City of Boise
ADA Assessment

Appendix A – Library! At Bown Crossing

Report # TO21-B014

ID: 2579 **Facility:** Bown Crossing Library

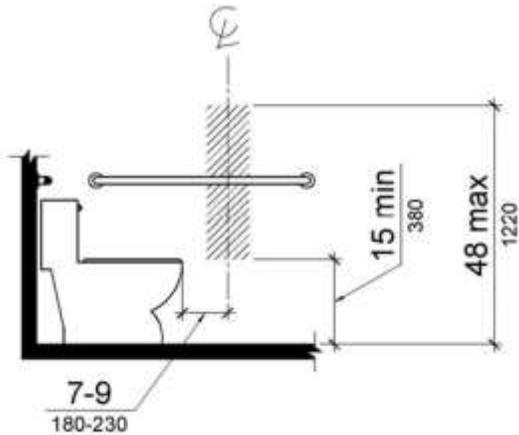
2010 ADA Standards for Accessible Design Codes §604.7
The toilet paper dispenser is located out of the accessible reach range.

Remount the toilet paper dispenser to 7" minimum and 9" maximum in front of the water closet measured to the centerline of the dispenser.
The outlet of the dispenser shall be 15" minimum and 48" maximum above the floor and shall not be located behind.

ID: 2583 **Facility:** Bown Crossing Library

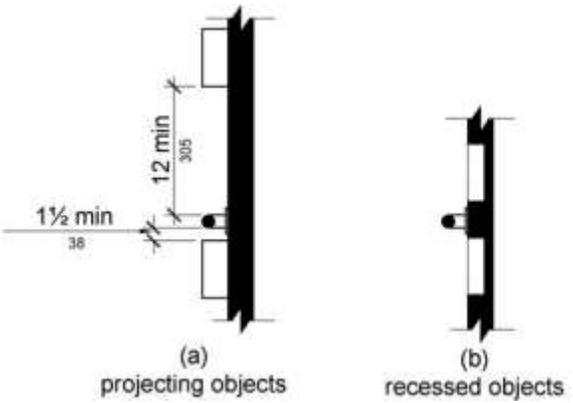
2010 ADA Standards for Accessible Design Codes §609.3
The space between the grab bar and the shelf is 9.5".

Relocate the shelf to a location that is at least a distance of 12" or greater above the grab bar. Ensure that the shelf is not greater than 48" above the floor.

ID: 2539 **Facility:** Bown Crossing Library

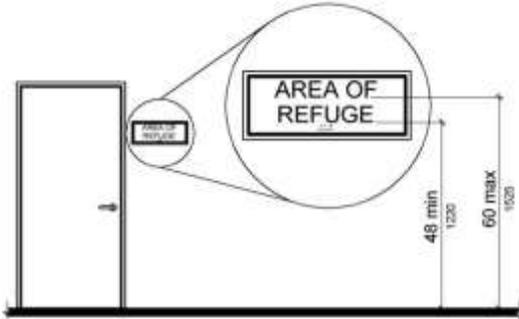
2010 ADA Standards for Accessible Design Codes §216.2, §703
There is no tactile sign identifying the permanent room

Install tactile signage to the right of the right hand door at a height of 48" minimum to 60" maximum above the floor, identifying room by name or room number.
Signs shall be Braille with raised lettering and should be placed on the wall in the center of an 18"x18" clear floor space.

ID: 2569 **Facility:** Bown Crossing Library

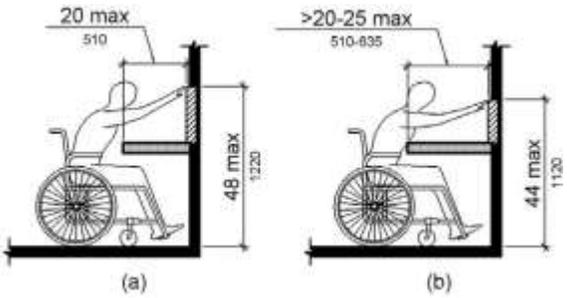
2010 ADA Standards for Accessible Design Codes §308.2.2
The paper towel dispenser is outside of the obstructed forward reach range at 46" above the floor.

Lower the paper towel dispenser by 2" to meet the accessible reach range of 44" maximum above the floor.

ID: 2568 **Facility:** Bown Crossing Library

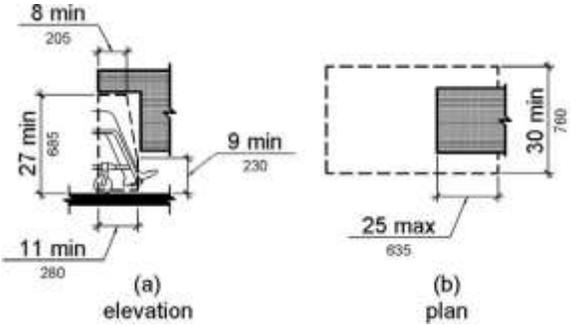
2010 ADA Standards for Accessible Design Codes §306.3.3
There is no knee clearance underneath the counter.

Provide knee clearance underneath the counter at the sink that is a minimum of 11" deep at 9" above the floor and 8" deep at 27" above the floor.

ID: 2552 **Facility:** Bown Crossing Library

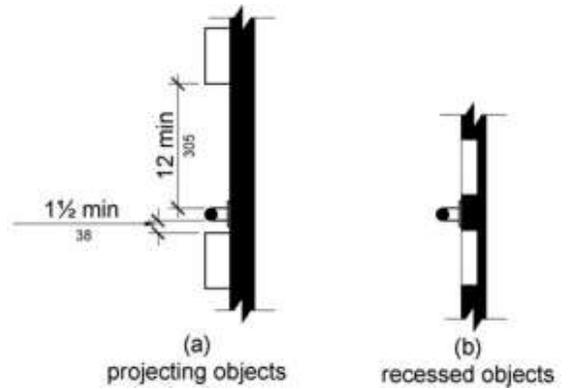
2010 ADA Standards for Accessible Design Codes §609.3
The space between the grab bar and the shelf is 9.5".

Relocate the shelf to a location that is at least a distance of 12" or greater above the grab bar. Ensure that the shelf is not greater than 48" above the floor.

ID: 2554 **Facility:** Bown Crossing Library

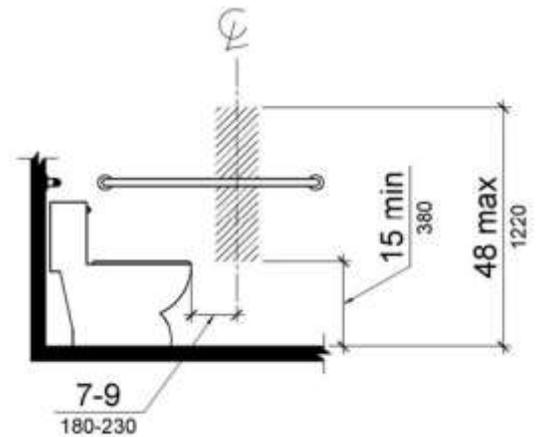
2010 ADA Standards for Accessible Design Codes §604.7

The toilet paper dispenser is located out of the accessible reach range.

Remount the toilet paper dispenser to 7" minimum and 9" maximum in front of the water closet measured to the centerline of the dispenser.

The outlet of the dispenser shall be 15" minimum and 48" maximum above the floor and shall not be located behind.

ID: 2556 **Facility:** Bown Crossing Library

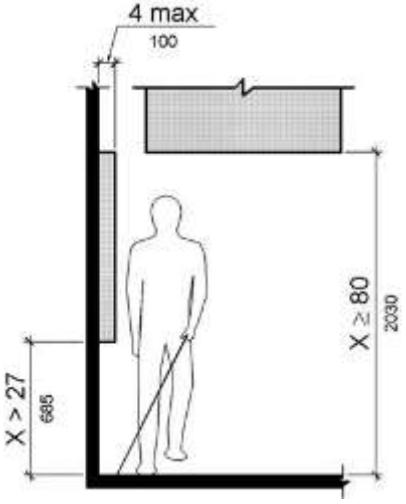
2010 ADA Standards for Accessible Design Codes §307.2, §308.2.1
The sharps container is outside of the unobstructed forward reach range at 49.5" above the floor. The sharps container protrudes 4.75" into the circulation space at 49.5" above the floor.

Lower the sharps container by 1.5" to meet the accessible reach range of 48" maximum above the floor.
Recess the sharps container so it protrudes a maximum of 4" or place a cane detectable object beneath it.

ID: 2553 **Facility:** Bown Crossing Library

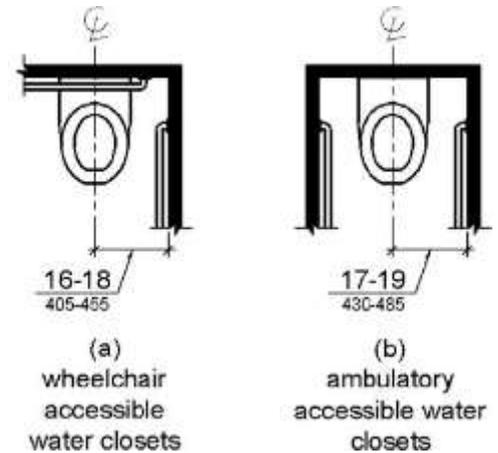
2010 ADA Standards for Accessible Design Codes §604.2

The centerline of the toilet is located 19" from the sidewall

Reposition the centerline of the toilet to be within 16" minimum and 18" maximum from the sidewall.

ID: 2547 **Facility:** Bown Crossing Library

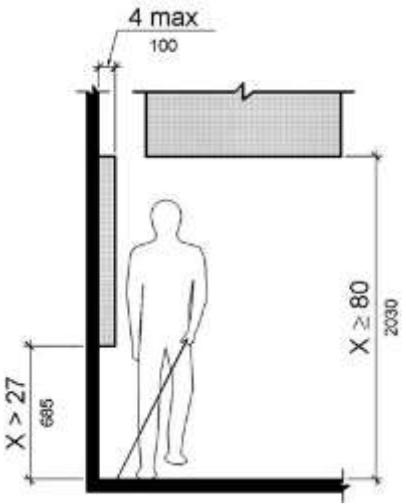
2010 ADA Standards for Accessible Design Codes §307.2
The Vox Poplar art protrudes 14" into the circulation space at 71.5" above the floor.

Recess the Vox Poplar art so it protrudes a maximum of 4", lower it so the bottom edge is 27" maximum above the floor, or place a cane detectable object beneath it.

ID: 2562 **Facility:** Bown Crossing Library

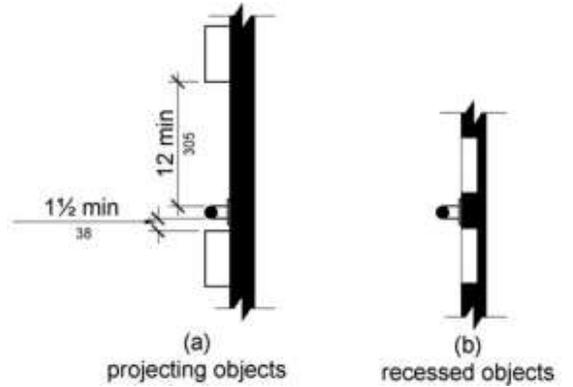
2010 ADA Standards for Accessible Design Codes §609.3
The space between the grab bar and shelf is 9.75".

Relocate the shelf to a location that is at least a distance of 12" or greater above the grab bar. Ensure that the shelf is not greater than 48" above the floor.

ID: 2564 **Facility:** Bown Crossing Library

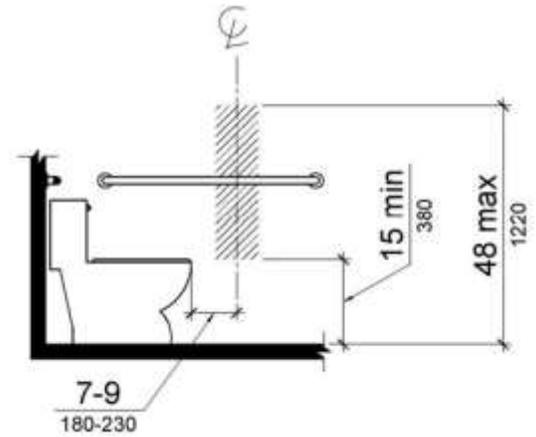
2010 ADA Standards for Accessible Design Codes §604.7

The toilet paper dispenser is located out of the accessible reach range.

Remount the toilet paper dispenser to 7" minimum and 9" maximum in front of the water closet measured to the centerline of the dispenser.

The outlet of the dispenser shall be 15" minimum and 48" maximum above the floor and shall not be located behind.

ID: 2565 **Facility:** Bown Crossing Library

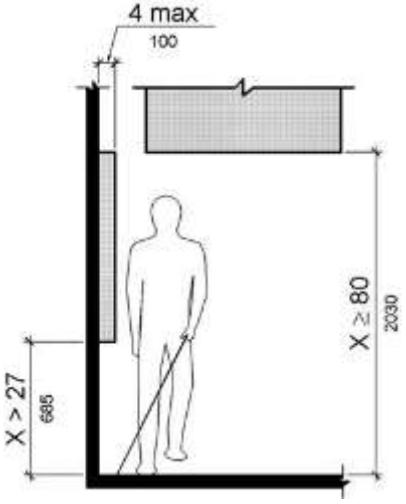
2010 ADA Standards for Accessible Design Codes §307.2, §308.2.1

The sharps container is outside of the unobstructed forward reach range at 49" above the floor. The sharps container protrudes 4.75" into the circulation space at 49" above the floor.

Lower the sharps container by 1" to meet the accessible reach range of 48" maximum above the floor.

Recess the sharps container so it protrudes a maximum of 4" or place a cane detectable object beneath

ID: 2563 **Facility:** Bown Crossing Library

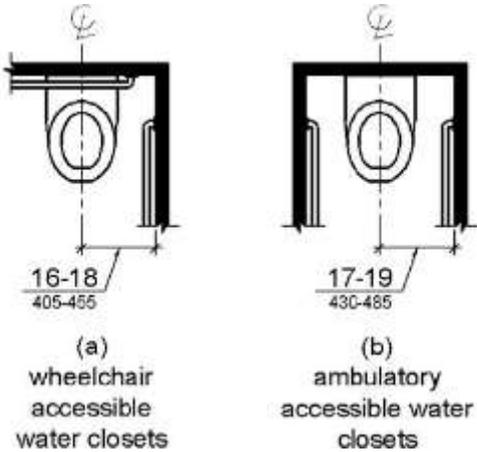
2010 ADA Standards for Accessible Design Codes §604.2
The centerline of the toilet is located 18.5" from the sidewall.

Reposition the centerline of the toilet to be within 16" minimum and 18" maximum from the sidewall.

ID: 2573 **Facility:** Bown Crossing Library

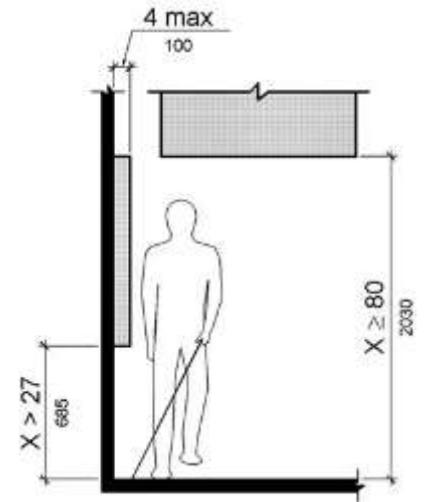
22010 ADA Standards for Accessible Design Codes §307.2

The TV protrudes 5" into the circulation space at 45.5" above the floor.

Ensure that the desk remains underneath the TV to provide cane detectability.

ID: 2574 **Facility:** Bown Crossing Library

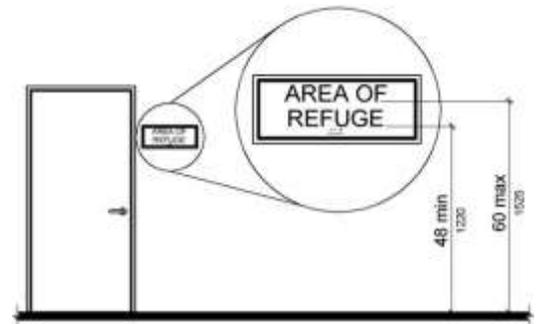
2010 ADA Standards for Accessible Design Codes §216.4, §703

Doors serving as exits are not marked by tactile signage.

Place a tactile exit sign, that complies with §703.1, §703.2 and §703.5, identifying the exit doors.

Install missing signage at 48" minimum above the floor measured from the baseline of the lowest character and 60" maximum measured from the baseline of the highest character.

ID: 2541 **Facility:** Bown Crossing Library

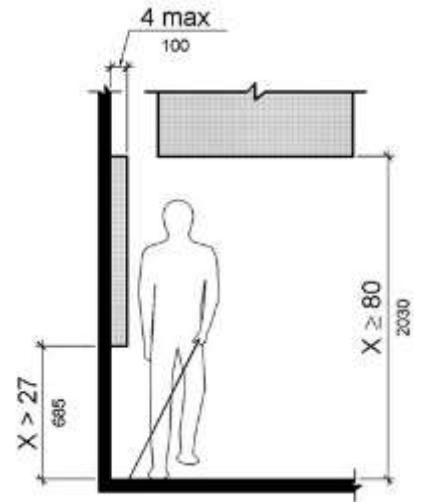
2010 ADA Standards for Accessible Design Codes §307.2

The desks protrude 14.75" into the circulation space at 33" above the floor.

Extend the sides of the desks down so the bottom edge is 27" maximum above the floor.

ID: 2543 **Facility:** Bown Crossing Library

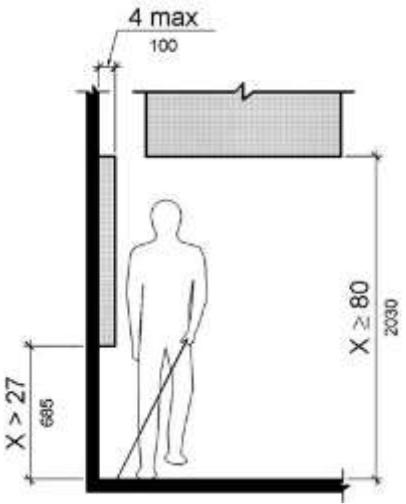
2010 ADA Standards for Accessible Design Codes §307.2
The mantle protrudes 7.25" into the circulation space at 64" above the floor.

Recess the mantle so it protrudes a maximum of 4", lower it so the bottom edge is 27" maximum above the floor, or place a cane detectable object beneath it.

ID: 2546 **Facility:** Bown Crossing Library

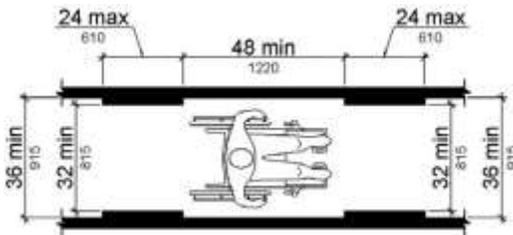
2010 ADA Standards for Accessible Design Codes §403.5.1
There is less than 36" for wheelchairs to pass between the blue couch, counters, blue chairs, and red chairs.

Rearrange the reading area to allow for a minimum of 36" between all the furniture, counters, and walls.

ID: 2542 **Facility:** Bown Crossing Library

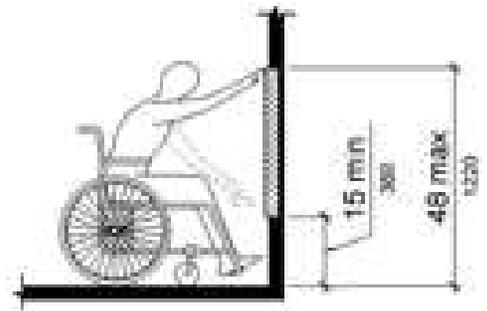
2010 ADA Standards for Accessible Design Codes §308.2.1

The top shelves are outside of the unobstructed forward reach range at 65" above the floor.

Ensure that the library has a policy that provides assistance to employees and volunteers reaching for shelves that are located beyond 48" above the floor.

ID: 2605 **Facility:** Bown Crossing Library

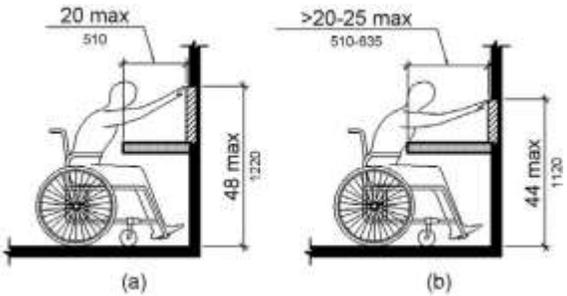
2010 ADA Standards for Accessible Design Codes §308.2.2
The paper towel dispenser is outside of the obstructed forward reach range at 47" above the floor however, the counter is 21" deep.

Lower the paper towel dispenser by 3" to meet the accessible reach range of 44" maximum above the floor.

ID: 2604 **Facility:** Bown Crossing Library

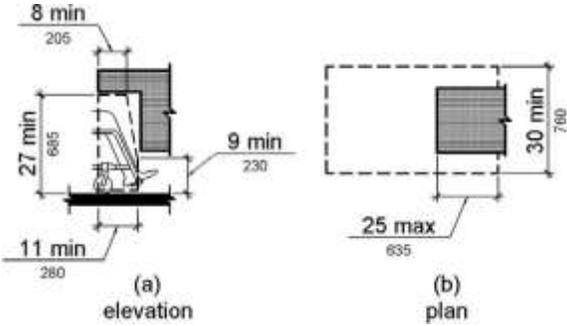
2010 ADA Standards for Accessible Design Codes §306.3.3
There is no knee clearance underneath the counter.

Provide knee clearance underneath the counter at the sink that is a minimum of 11" deep at 9" above the floor and 8" deep at 27" above the floor.

ID: 2588 **Facility:** Bown Crossing Library

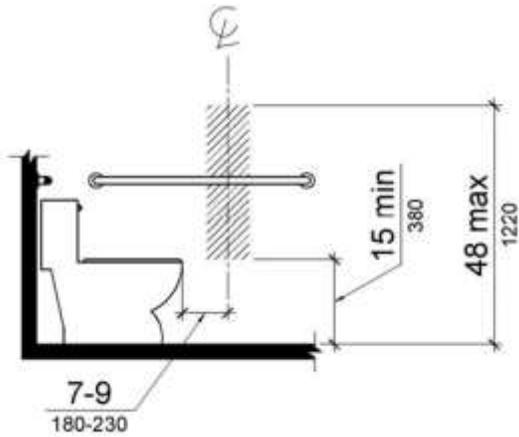
2010 ADA Standards for Accessible Design Codes §604.7
The toilet paper dispenser is located out of the accessible reach range.

Remount the toilet paper dispenser to 7" minimum and 9" maximum in front of the water closet measured to the centerline of the dispenser.
The outlet of the dispenser shall be 15" minimum and 48" maximum above the floor and shall not be located behind.

ID: 2592 **Facility:** Bown Crossing Library

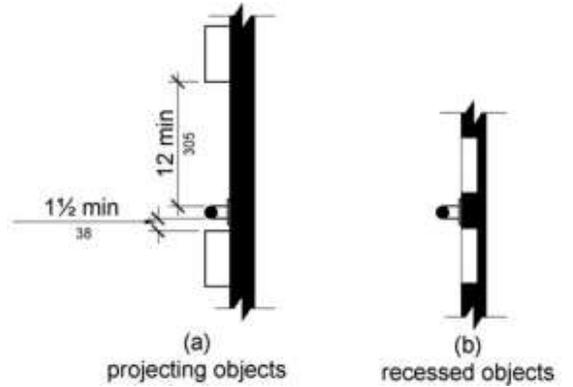
2010 ADA Standards for Accessible Design Codes §609.3
The space between the grab bar and shelf is 10".

Relocate the shelf to a location that is at least a distance of 12" or greater above the grab bar. Ensure that the shelf is not greater than 48" above the floor.

ID: 2596
Facility: Bown Crossing Library

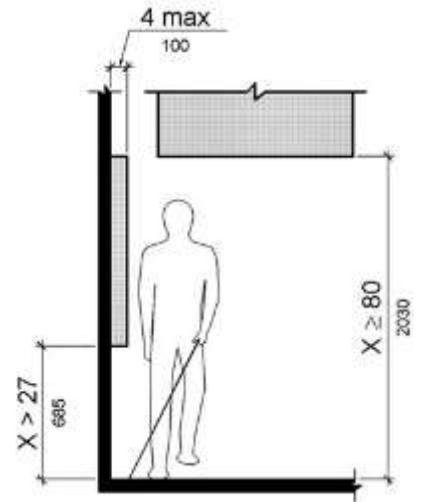
2010 ADA Standards for Accessible Design Codes §307.2

The shower curtain rod is 76" above the floor.

Raise the shower curtain rod to a minimum of 80" above the floor.

ID: 2586 **Facility:** Bown Crossing Library

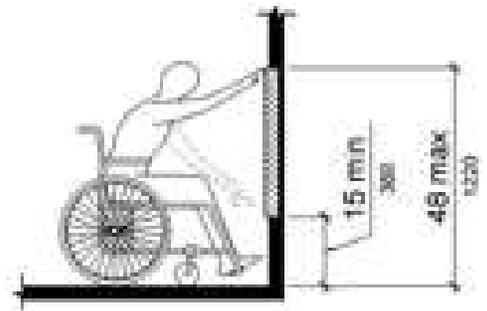
2010 ADA Standards for Accessible Design Codes §404.2.8.1
The time required for the door to shut is 3.08 seconds.

Adjust the closing speed to a minimum of 5 or more seconds.

ID: 4482 **Facility:** Bown Crossing Library

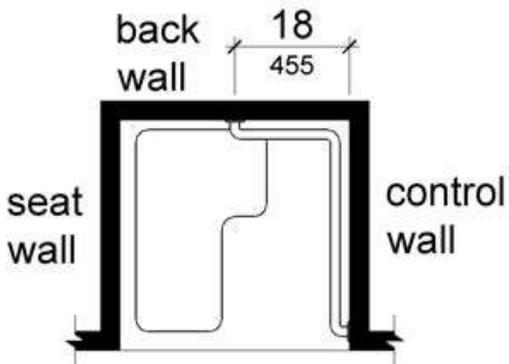
2010 ADA Standards for Accessible Design Codes §608.3, §609
There are no grab bars in the transfer shower.

Install grab bars across the control wall and back wall to a point 18" from the control wall at a maximum height of 36" above the bathroom floor.

ID: 2595 **Facility:** Bown Crossing Library

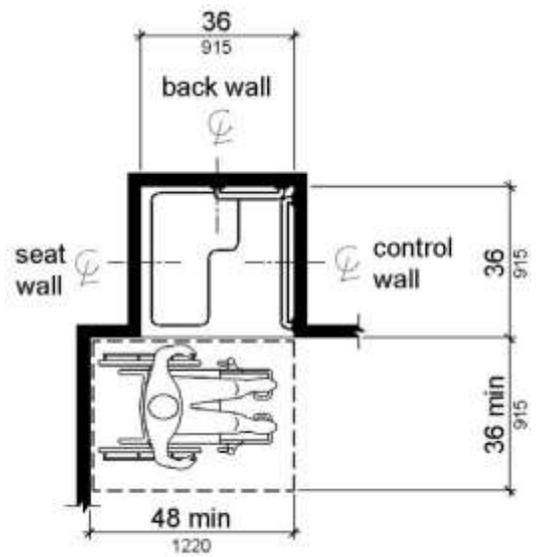
2010 ADA Standards for Accessible Design Codes §608.2.1
The shower dimensions do not meet the requirements for a transfer type shower at 34"x36".

Expand the transfer type shower compartment to meet the minimum dimensions of 36"x36" measured at the center points of opposing sides with a 36" wide minimum entry on the face of the shower compartment.

ID: 2603 **Facility:** Bown Crossing Library

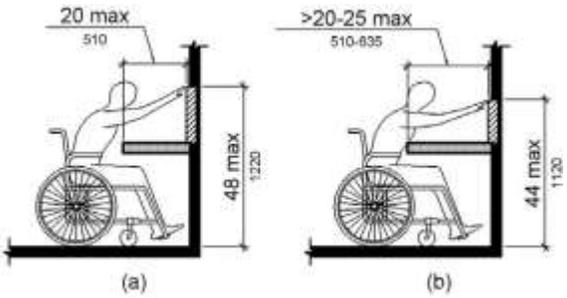
2010 ADA Standards for Accessible Design Codes §308.2.2
The paper towel dispenser is outside of the obstructed forward reach range at 45.4" above the floor.

Lower the paper towel dispenser by 1.5" to meet the accessible reach range of 44" maximum above the floor.

ID: 2602 **Facility:** Bown Crossing Library

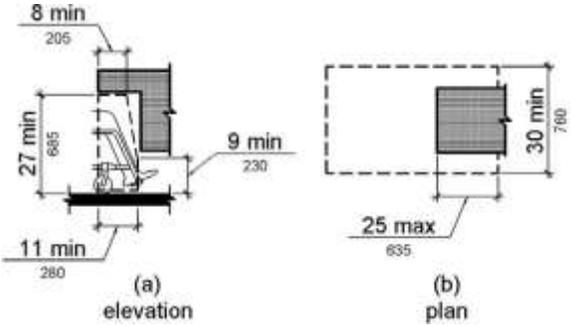
2010 ADA Standards for Accessible Design Codes §306.3.3
There is no knee clearance underneath the counter.

Provide knee clearance underneath the counter at the sink that is a minimum of 11" deep at 9" above the floor and 8" deep at 27" above the floor.
